DETAIL OF GUARD RAIL AT BRIDGE APPROACH DETAIL OF REST AREA DETAIL OF U-TURN TURNOUTS

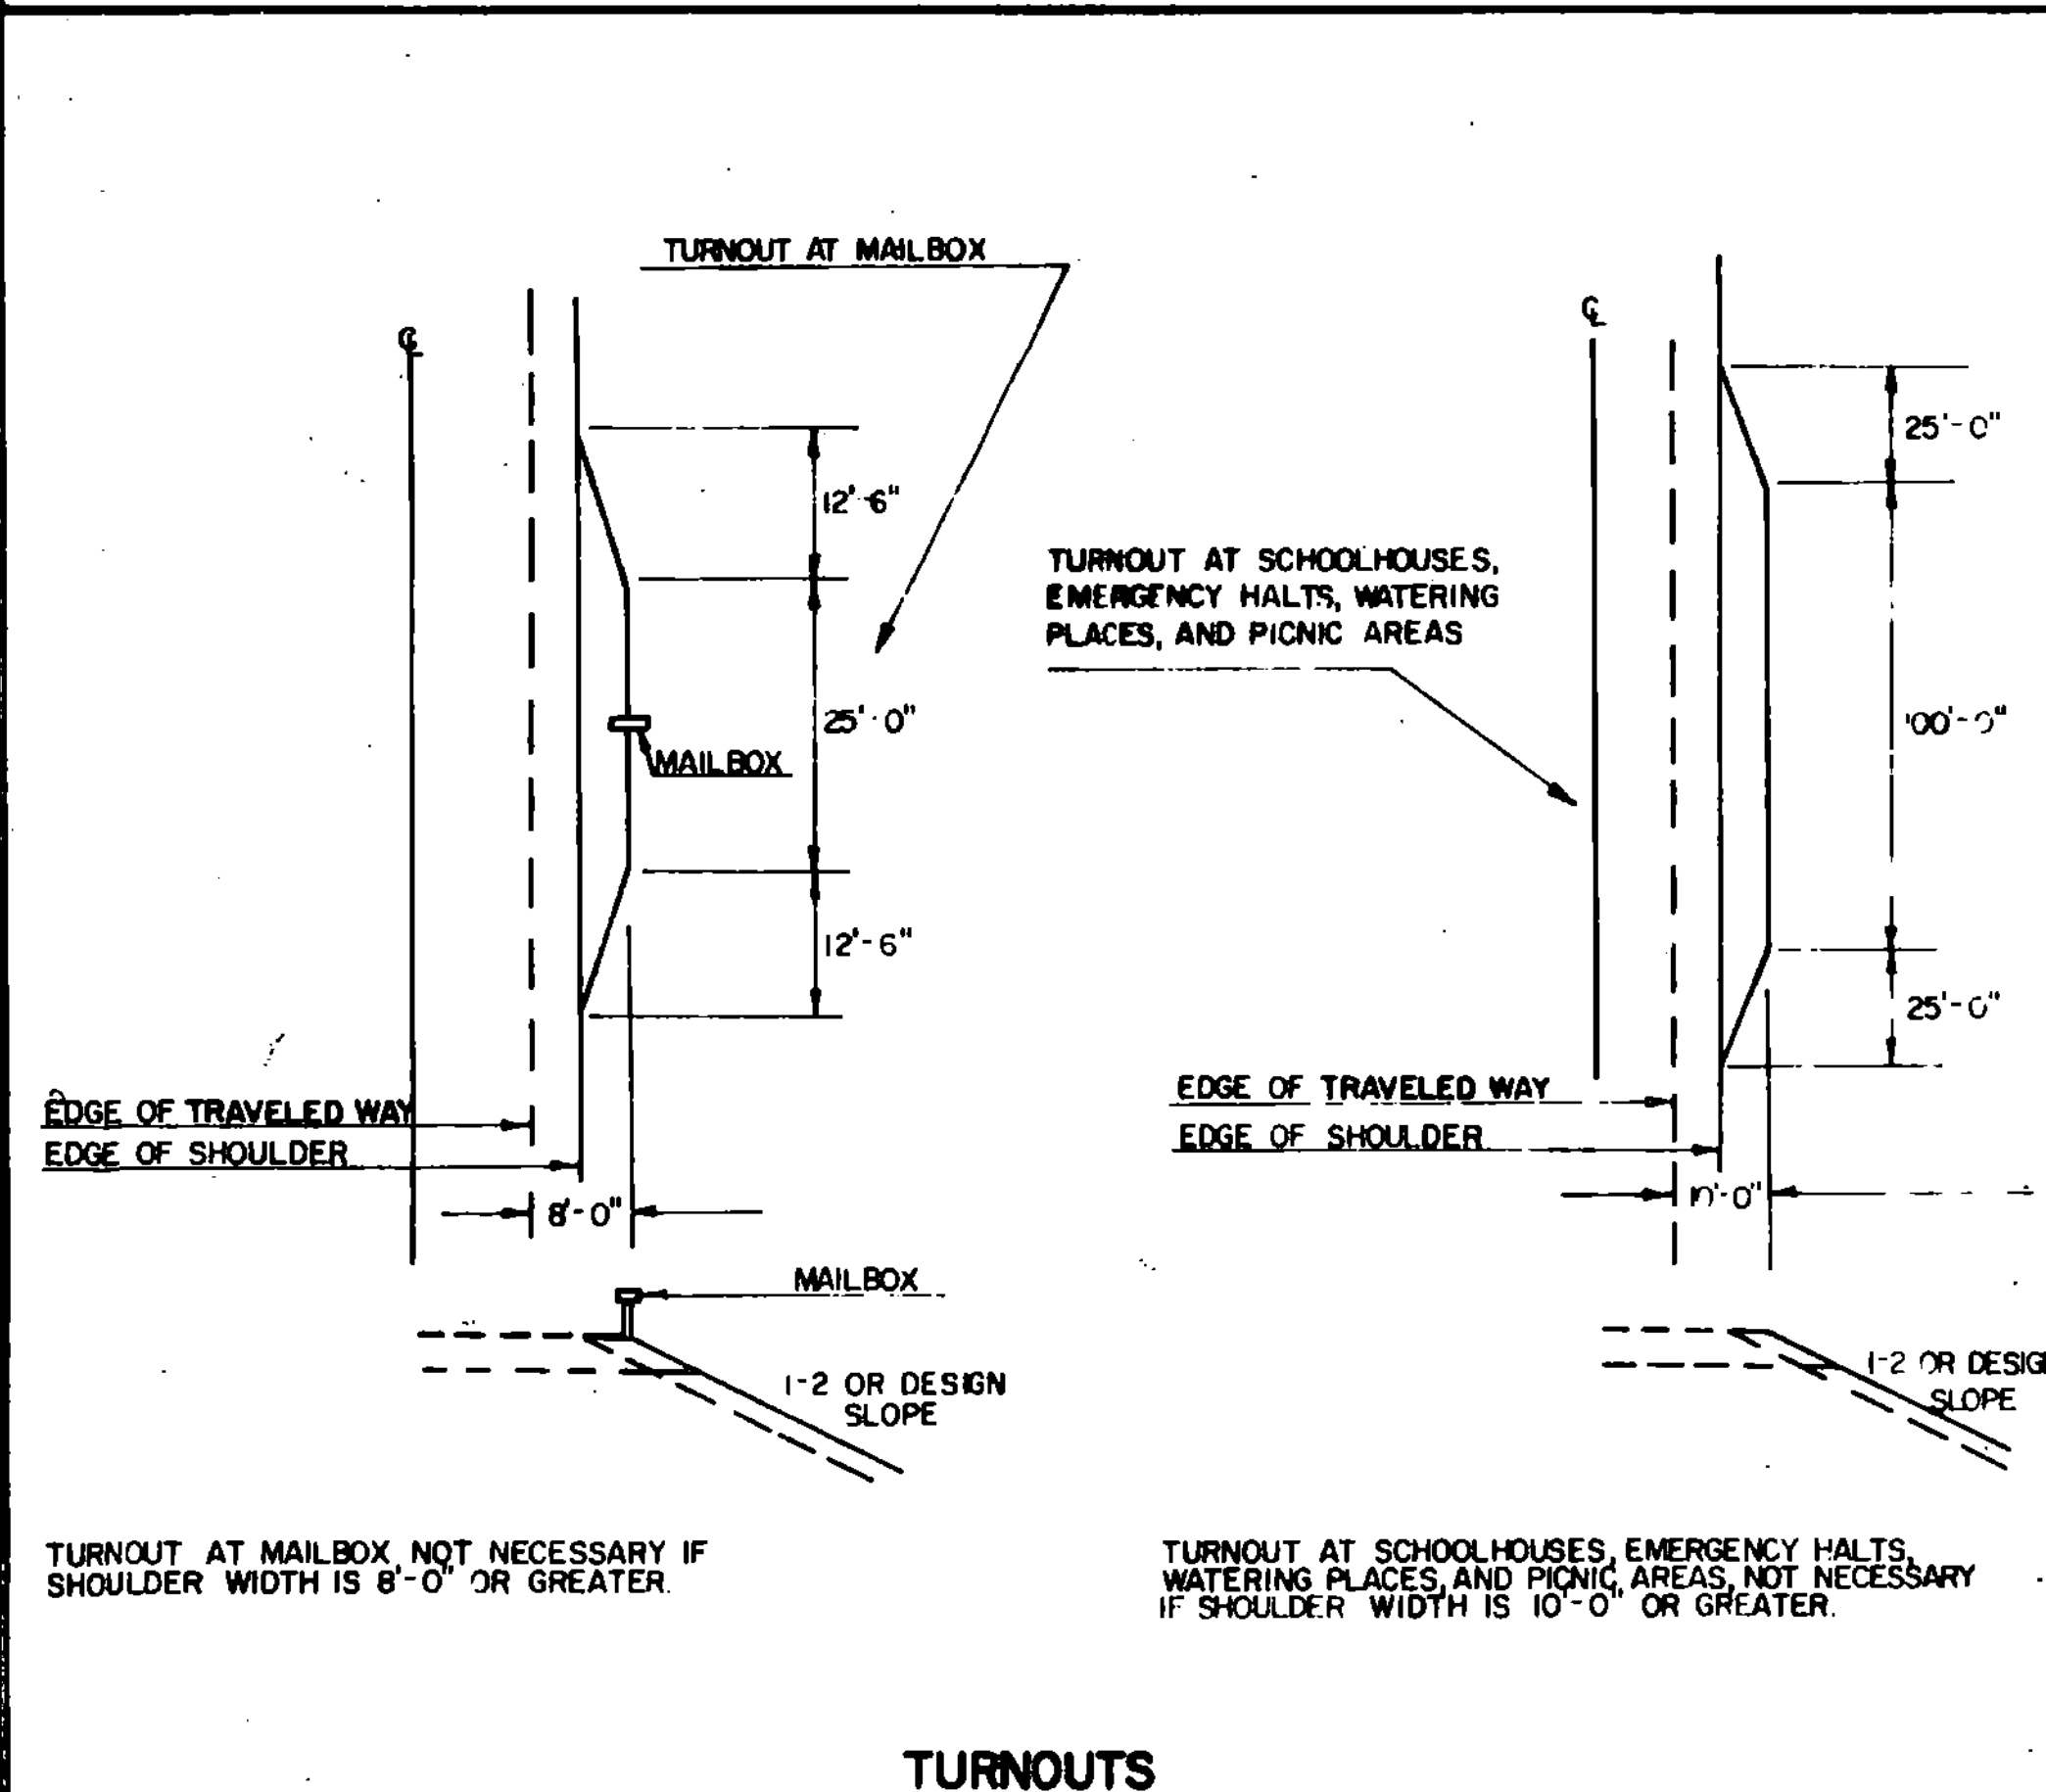
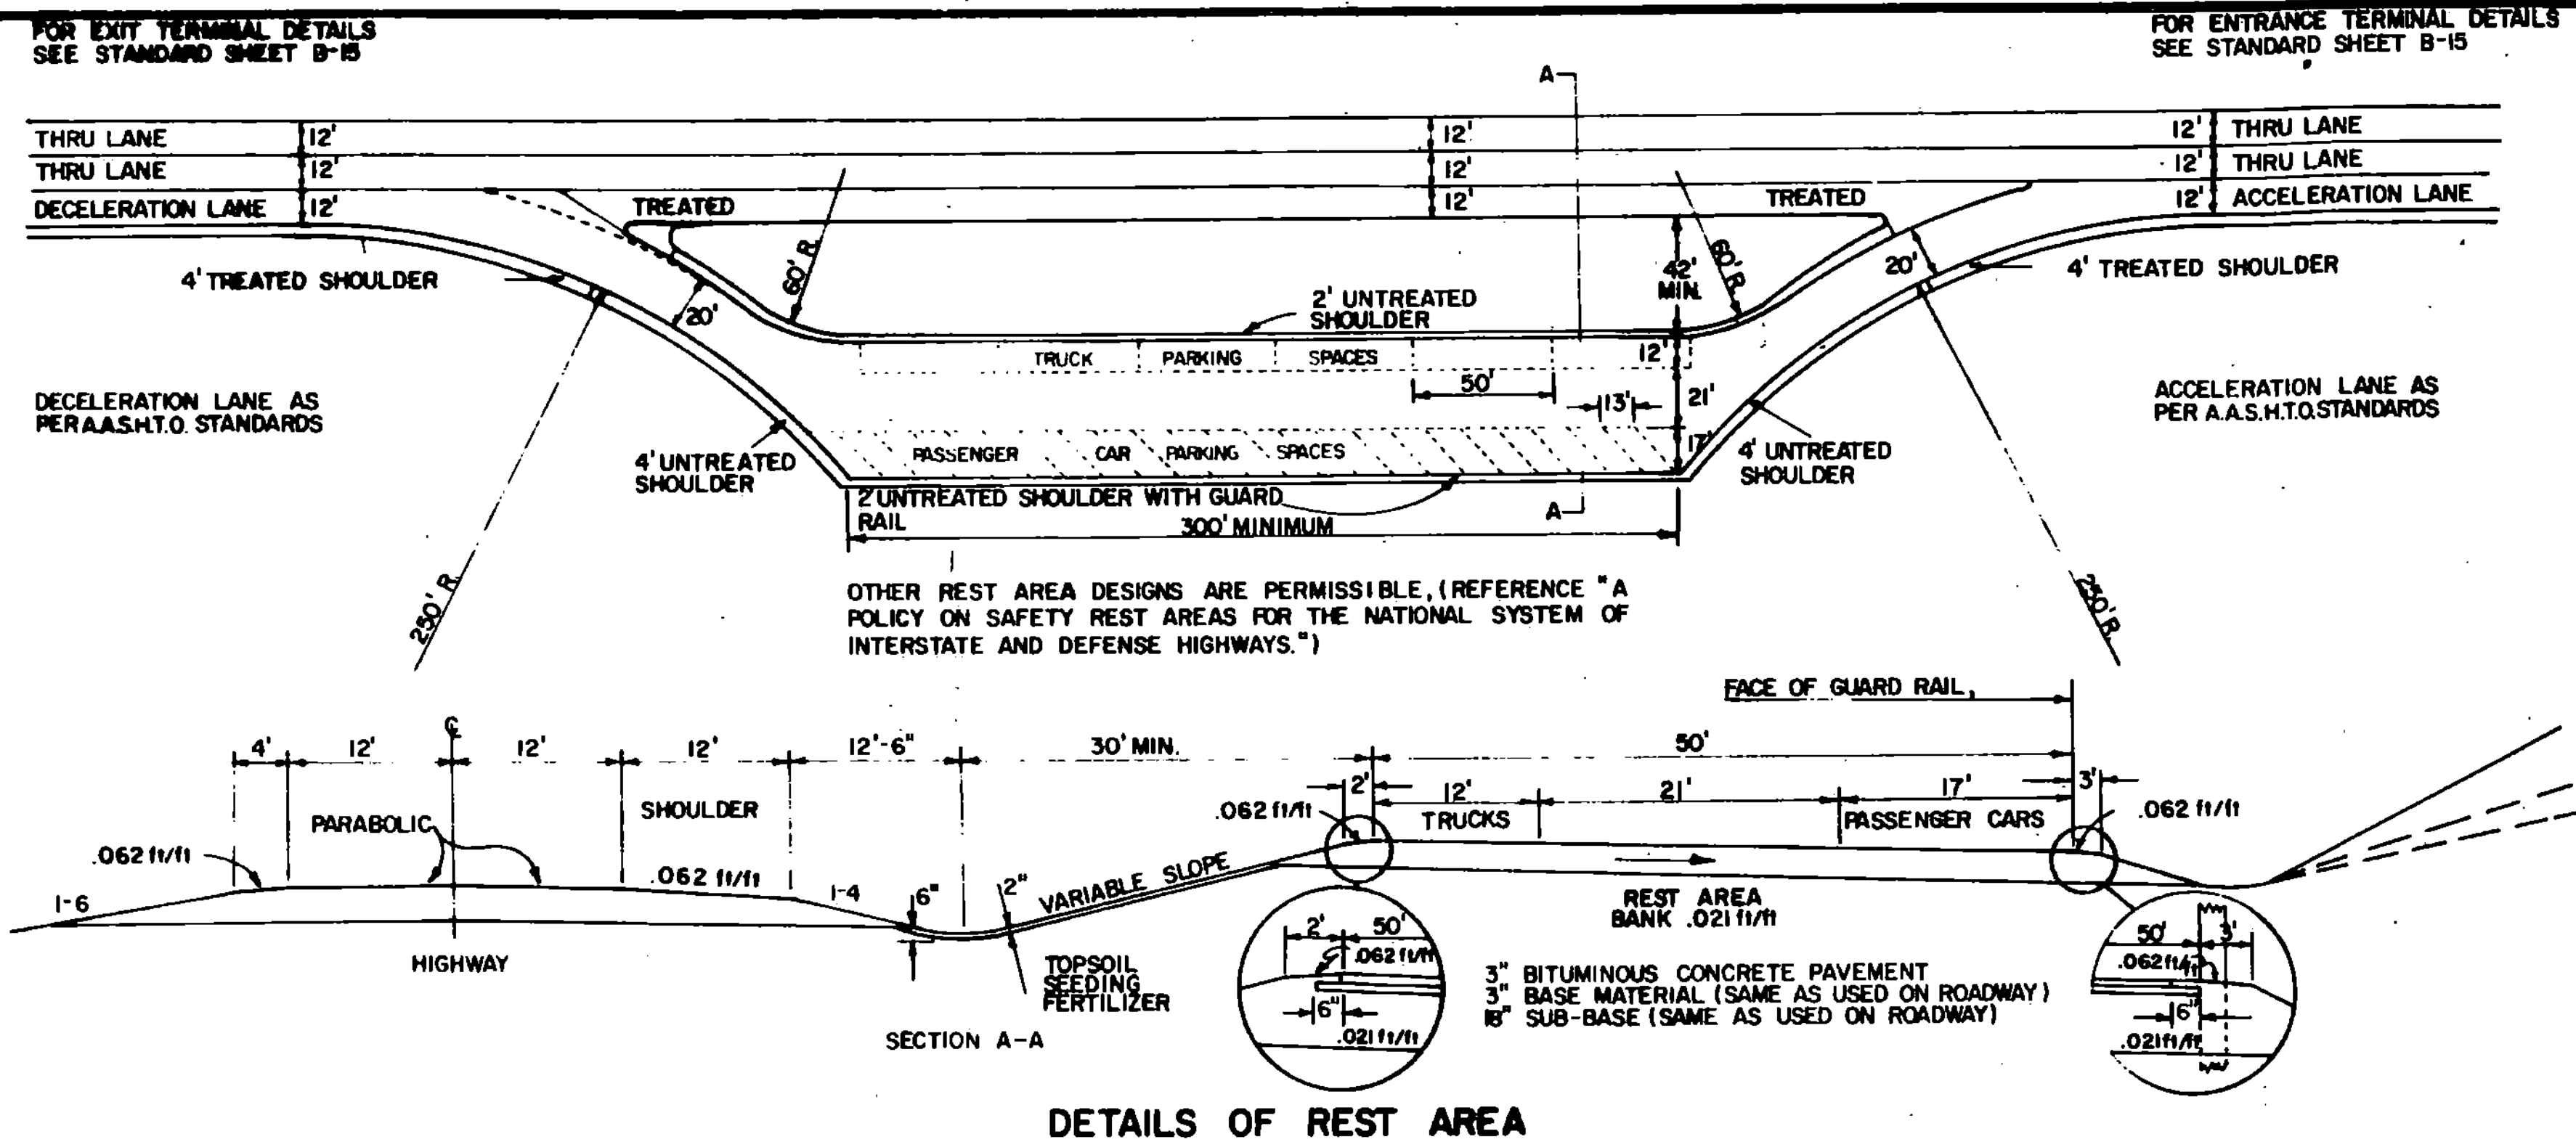
REVISIONS AND CORRECTIONS		APPROVED
DEC. 19, 1972	REFERENCE TO G-8 REMOVED. CEDAR LOG GUARD RAIL REMOVED FROM REST AREA.	DATE: <u>Dec. 8, 1971</u>
JUNE 11, 1973	G-8 ADDED TO EXIT SIDE OF STRUCTURES.	<u>R. H. Arnold</u>
DEC. 16, 1980	INCREASED SHOULDER WIDENING FOR GUARDRAIL; ADDED CLEAR ZONE WIDTH TO DETAIL OF TURNOUT W/GRASS PLOT; ADDED SECTION A-A FOR U-TURN.	CHIEF ENGINEER
OCT. 25, 1985	REVISED TO CONFORM TO 1986 SPECIFICATIONS, GUARD RAIL AT BRIDGE APPROACHES	<u>E. H. Stikney</u>
		ASST. CHIEF ENGINEER
		<u>G. M. Lane</u>
		HIGHWAY ENGINEER
